ADDENDUM #1
June 18, 2025

Middletown Junction Wellfield Development

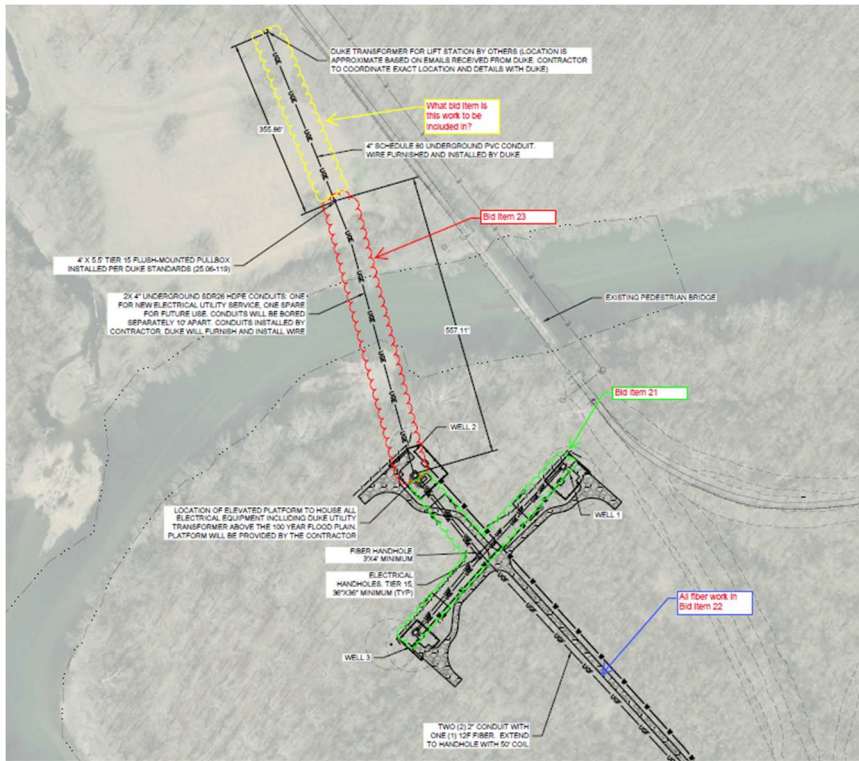
1. Sheet 3C1, Page 14 – **CHANGE** the Typical Water Meter Vault Layout to eliminate the sump pit as shown and instead provide a 24"x24"x3" deep shallow sump in the floor slab along the wall, next to hatch, and below the electrical outlet. The floor slab shall be solid and not open to the below subgrade.
2. Sheet 3E1 and 3E2, Page 25 and 26 – **ADD** the following General Note:
"6. SUMP PUMP PROVIDED BY OWNER."
3. Sheet 2Y5, Page 9 – **DELETE** the following note:
"4-INCH SCHEDULE 80 UNDERGROUND PVC CONDUIT BY OWNER. WIRE FURNISHED AND INSTALLED BY DUKE."

EXHIBIT A

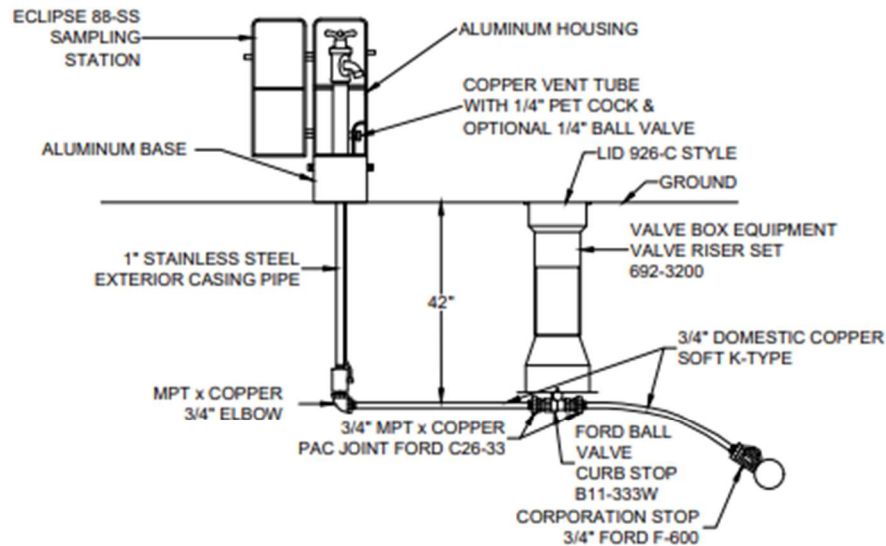
1. **Question:** The "Typical Water Meter Vault Layout" shown on page 14 shows a water sampling station and refers to a detail on sheet 4Y1. However there is no detail on 4Y1. Please provide this detail as well as the model number associated with the sampling station. **Response:** *Sample stations shall be as specified in Warren County Standard Detail W-23, which is included with this Addendum as EXHIBIT A.*

SAMPLING STATION TO BE REQUIRED ON EVERY NEW PLATTED SUBDIVISION.

SAMPLING STATIONS SHALL BE BURIED 42", WITH A 3/4" FIP INLET AND A (3/4" HOSE OR UNTHREADED) NOZZLE.

ALL STATIONS SHALL BE ENCLOSED IN A LOCKABLE, NONREMOVABLE, ALUMINUM CAST HOUSING.

WHEN OPENED, THE STATION SHALL REQUIRE NO KEY FOR OPERATION, AND THE WATER WILL FLOW IN AN ALL BRASS WATERWAY.

ALL WORKING PARTS WILL ALSO BE OF BRASS AND BE REMOVABLE FROM ABOVE GROUND WITH NO DIGGING. EXTERIOR PIPING SHALL BE BRASS OR STAINLESS STEEL.

A COPPER VENT TUBE WILL ENABLE EACH STATION TO BE PUMPED FREE OF STANDING WATER TO PREVENT FREEZING AND TO MINIMIZE BACTERIA GROWTH.

ECLIPSE NO. #88-SS SAMPLING STATION SHALL BE MAUFACTURED BY KUPFERIA FOUNDRY, ST LOUIS, MO 63102.
